**Economic and Social Council**Distr.: General
3 September 2024

Economic Commission for Europe**Inland Transport Committee****World Forum for Harmonization of Vehicle Regulations****194th session**

1958 Agreement:**Consideration of draft amendments to existing****UN Regulations submitted by GRE****Proposal for the 07 series of amendments to UN Regulation
No. 10 (Electromagnetic compatibility)****Submitted by the Working Party on Lighting and Light-Signalling***

"Figure 1

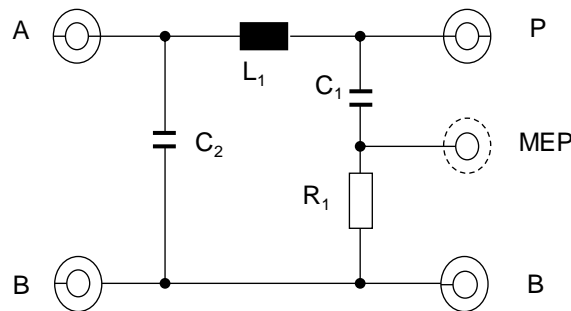
Paragraph 1., figure 1, amend to read:

Example of 5 μH AN schematic

"Figure 3

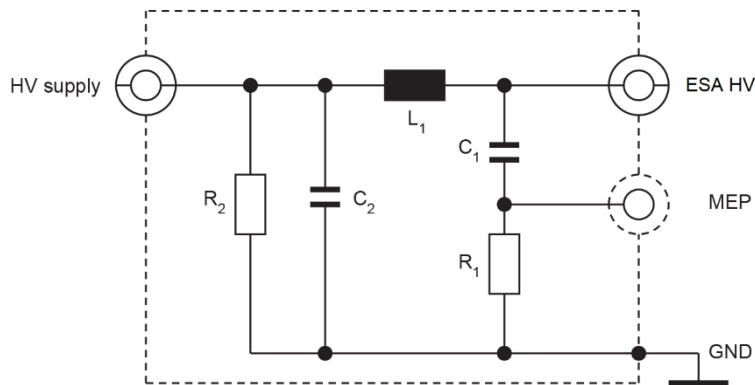
Paragraph 2., figures 3, 4 and 5, amend to read:

Example of 5 μH / HV-AN schematic

"Figure 4

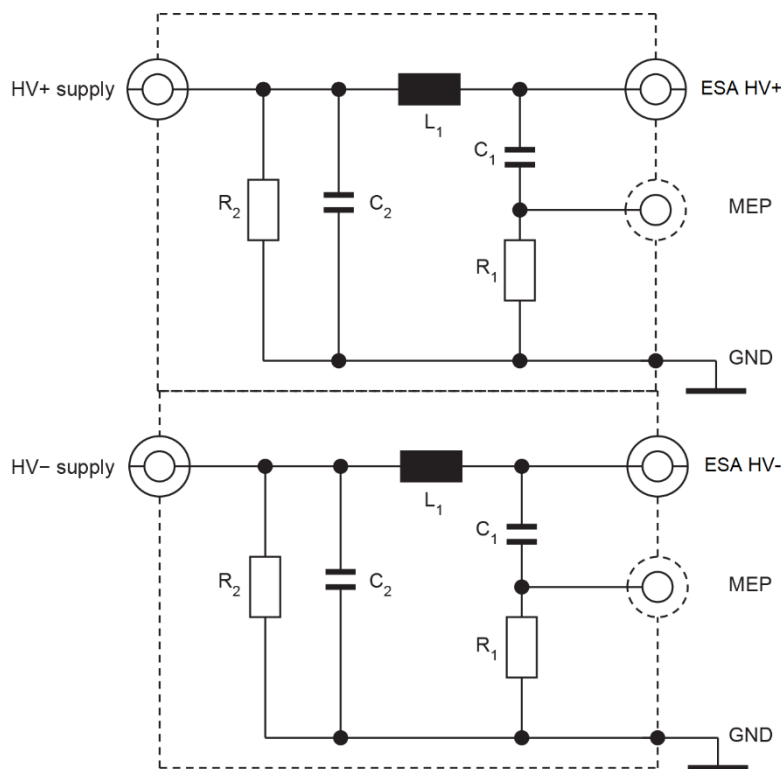
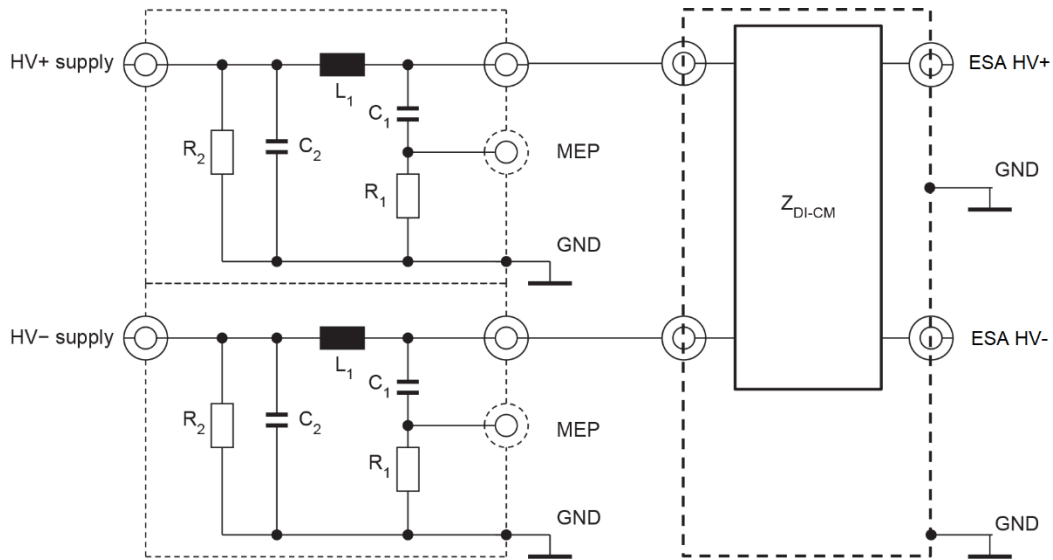
If unshielded HV ANs are used in a single shielded box, then there shall be an inner shield between the HV ANs as described in Figure 4."

Example of 5 μH HV AN combination in a single shielded box

Figure 1
Charging mode configuration for Annex 4

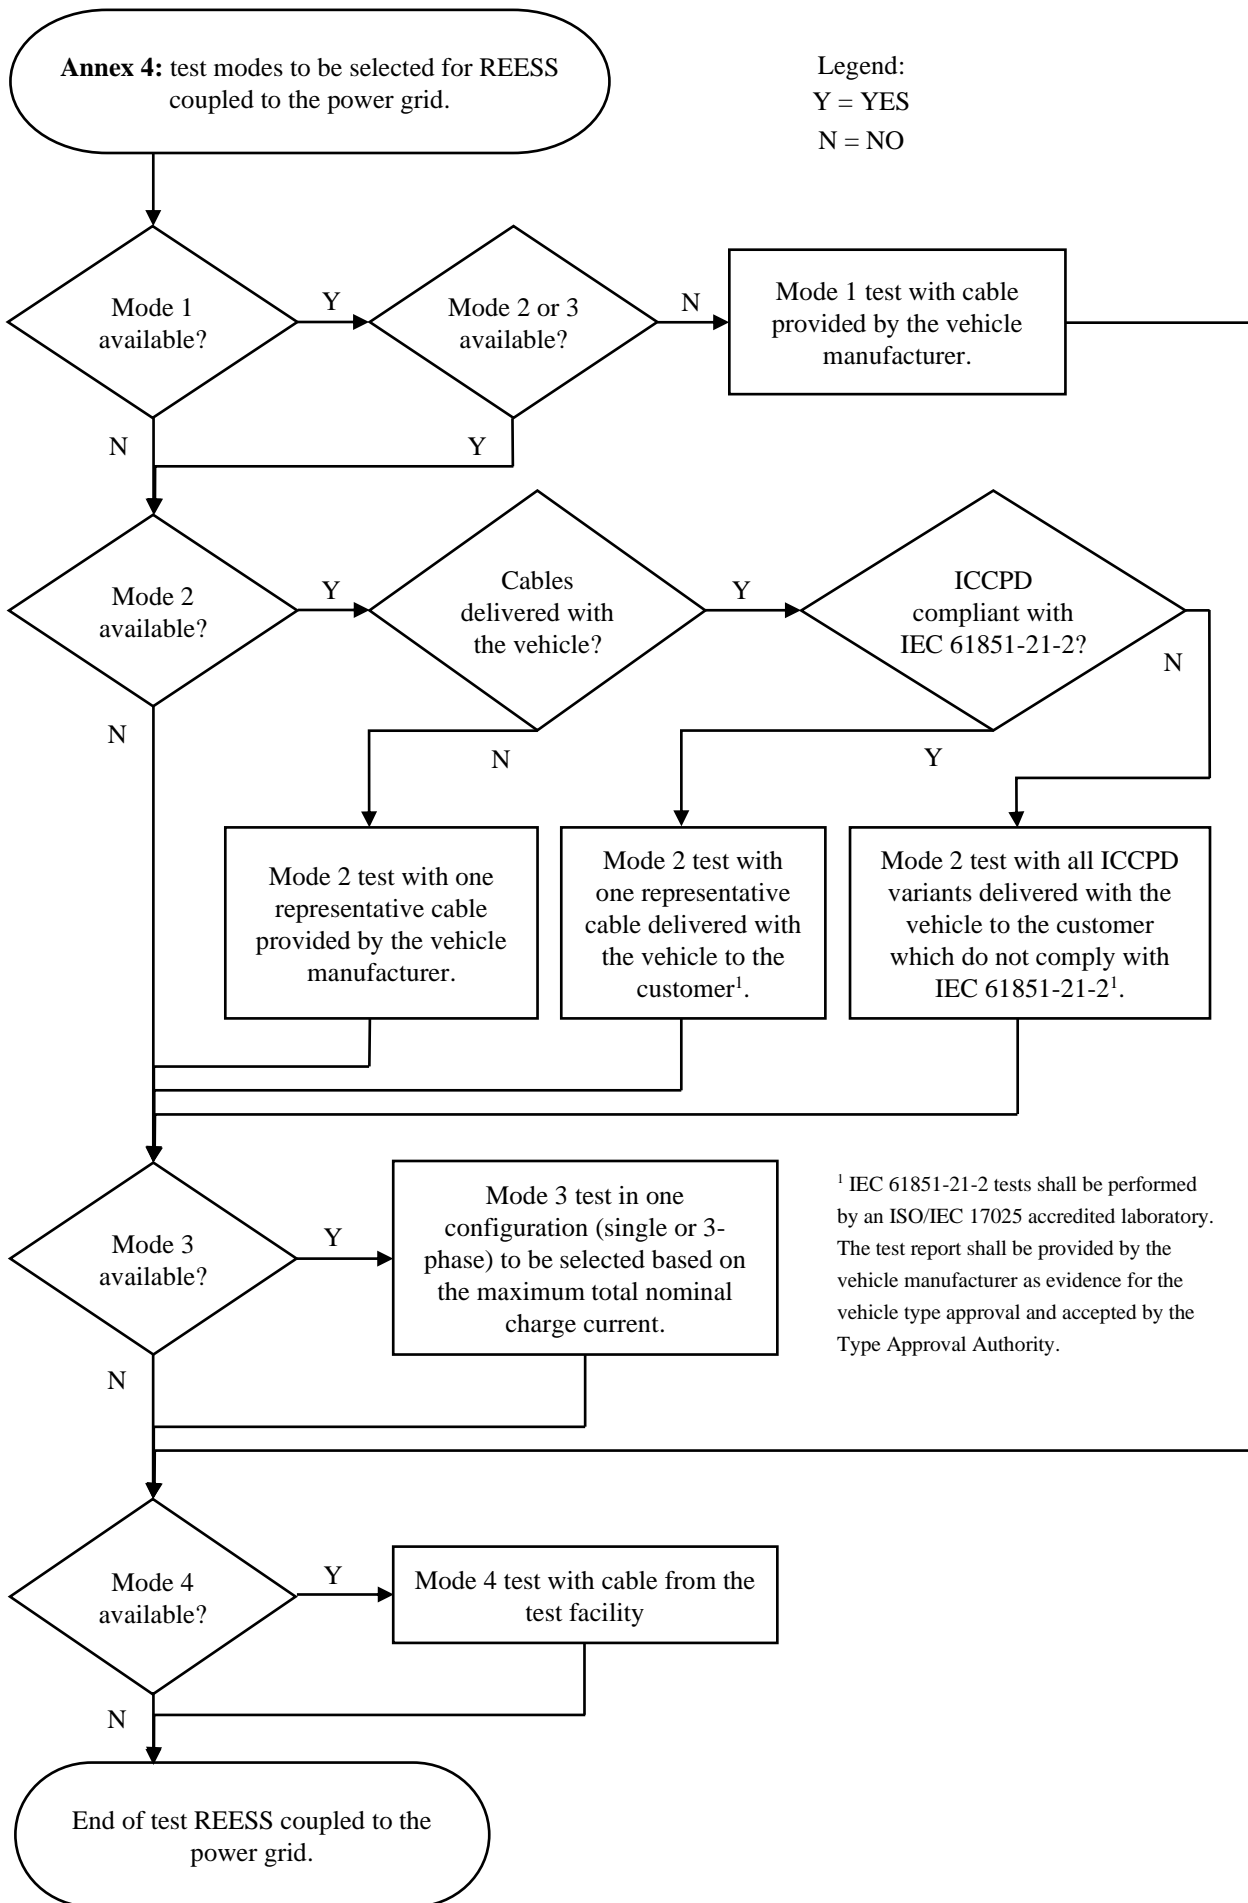
Paragraph 2.2., amend to read:

- "2.2. Vehicle in configuration "REESS charging mode coupled to the power grid".
The vehicle shall be tested in the charging mode configuration (if available on vehicle) as defined in flowchart of Figure 1.

The state of charge (SOC) of the traction battery shall be kept between 20 per cent and 80 per cent of the maximum SOC during the whole frequency range measurement (this may lead to splitting the measurement into different sub-bands with the need to discharge the vehicle's traction battery before starting the next sub-bands).

Figure 3

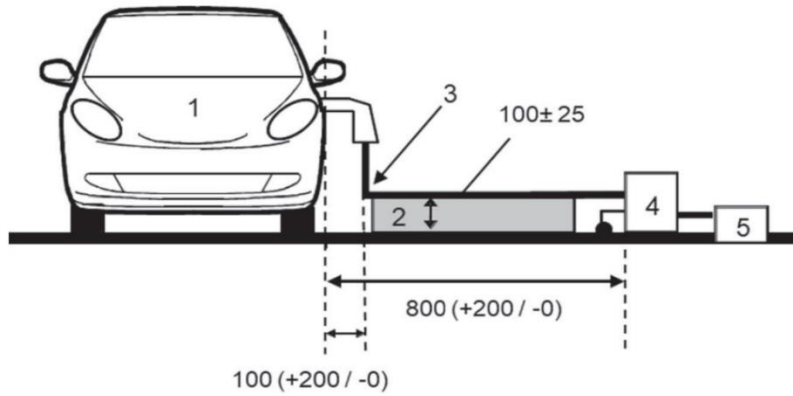
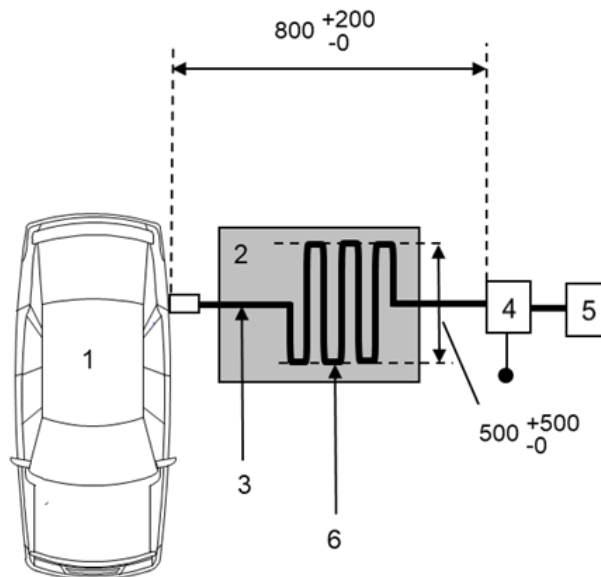
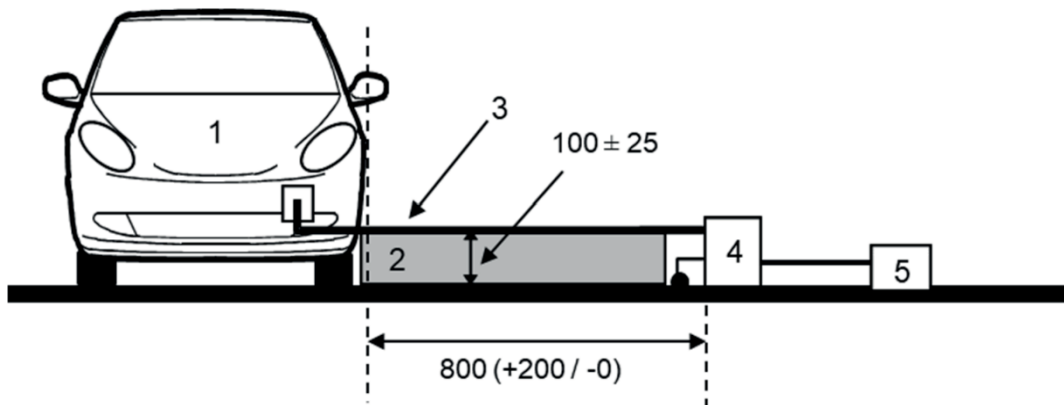
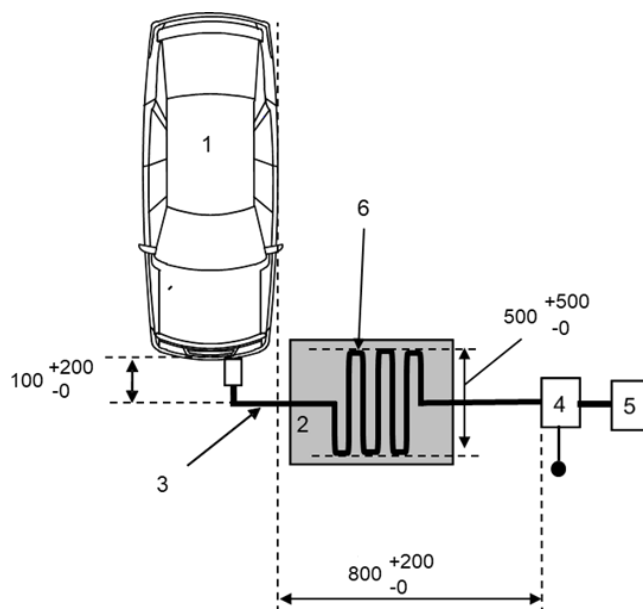
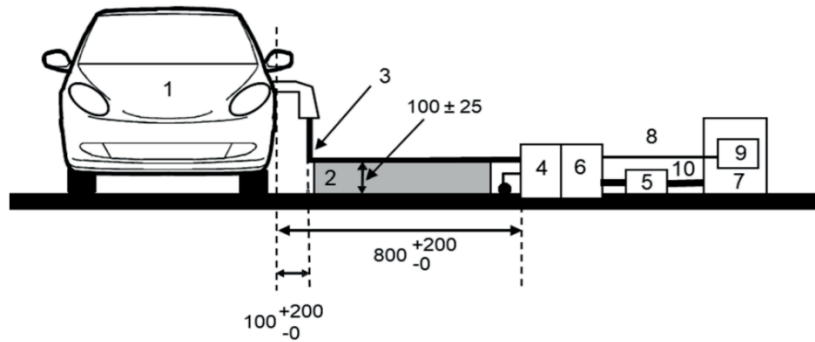
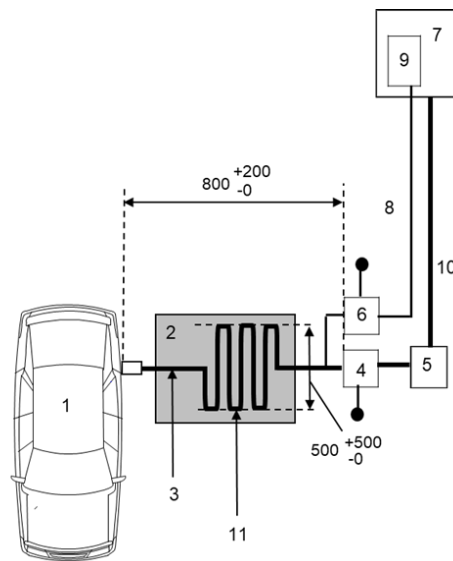
The power charging harness shall be placed in a straight line between the AMN(s) and the vehicle charging plug and shall be routed perpendicularly to the vehicle longitudinal axis (see Figure 3a and Figure 3c). The projected harness length from the side of the AMN(s) to the side of the vehicle shall be 0,8 (+0,2 / -0) m as shown in Figure 3b and Figure 3d.

The power charging local/private communication harness shall be laid out in a straight line between the AMN(s) / DC-charging-AN(s) / AAN(s) and the vehicle charging socket and shall be routed perpendicularly to the vehicle's longitudinal axis (see Figure 3e and Figure 3g). The projected harness length from the side of the AMN(s) to the side of the vehicle shall be 0,8 (+0,2 / -0) m as shown in Figure 3f and Figure 3h.

The whole harness shall be placed on a non-conductive, low relative permittivity (dielectric-constant) material ($\epsilon_r \leq 1,4$), at (100 ± 25) mm above the ground plane (ALSE) or floor (OTS)."

The whole harness shall be placed on a non-conductive, low relative permittivity (dielectric-constant) material ($\epsilon_r \leq 1,4$), at (100 \pm 25) mm above the ground plane (ALSE) or floor (OTS)."

Figure 1

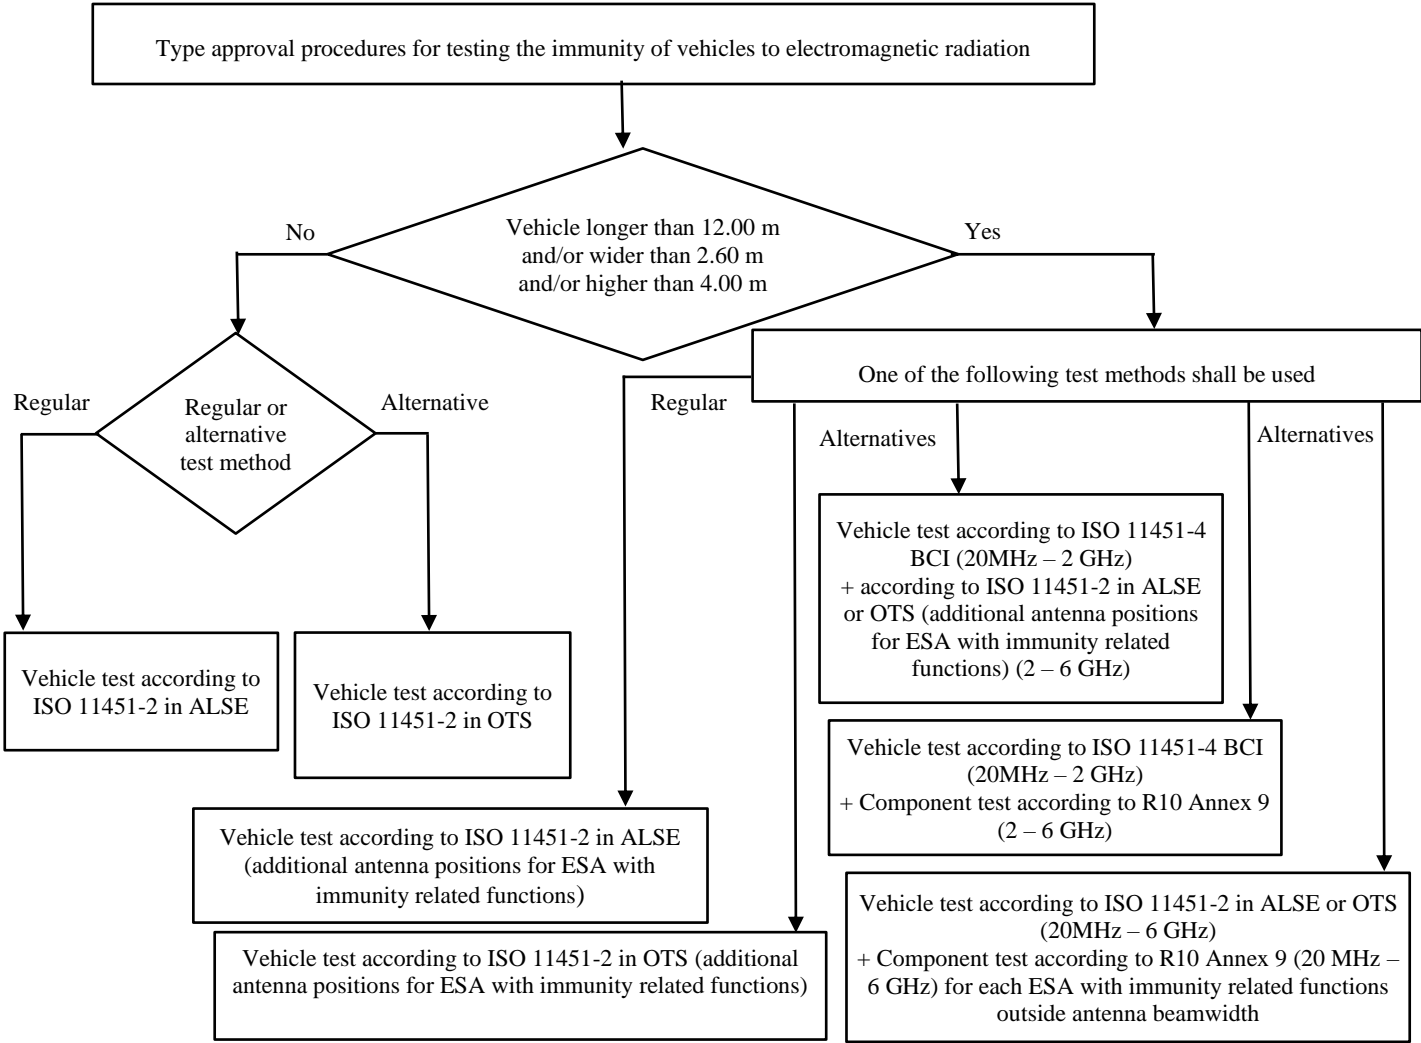
Insert a new paragraph 1.4., to read:

"1.4 Applicability of test methods:

Figure 2
Charging mode configuration for Annex 6

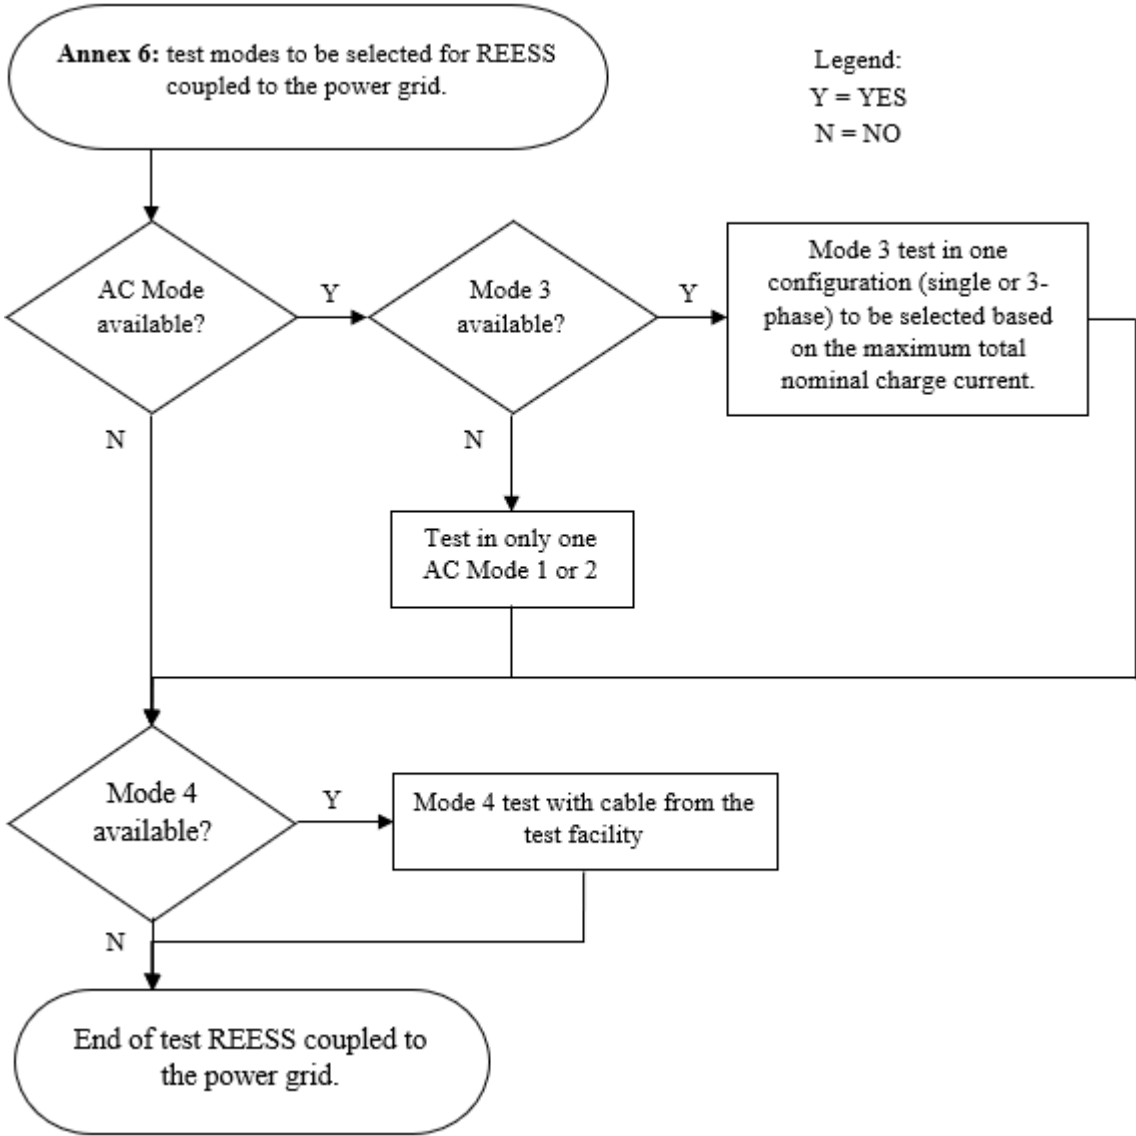
"2.2.1.1. The vehicle shall be immobilized, the engine(s) (ICE and / or electrical engine) shall be OFF and in charging mode.

The vehicle shall be tested in the charging mode configuration (if available on vehicle) as defined in flowchart of Figure 2.
